ESV Validation Report

Powercor 2017-2018
Fire Start Report

Figure 1: The location of incident 20180129PWA_02 relative to the location area boundary

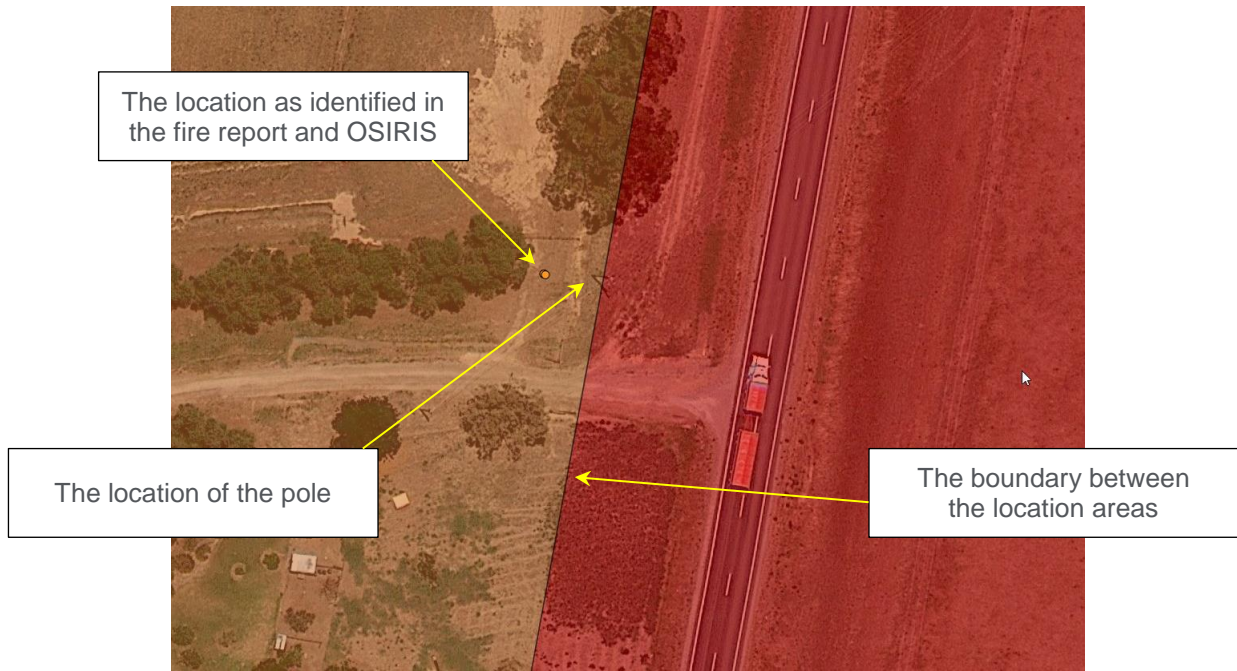
| OSIRIS report | Amend OSIRIS | Amend fire start report | ESV and Powercor commentary |
|----------------|--------------|-------------------------|--|
| 20180129PWA_02 | No | No | <p>The location of the pole listed in the fire start report is in an area designated “within area delineated on plan LEGL./16-354” rather than the higher risk zone listed in the fire start report (Figure 1).</p> <p>Powercor advised that, while the pole that was impacted lies in the lower risk zone, the cable that came to ground crossed the road and into the higher risk zone. The point at which the fire occurred was in the higher risk zone. Figure 2 shows the location of the fire relative to the pole that was impacted by the vehicle.</p> |
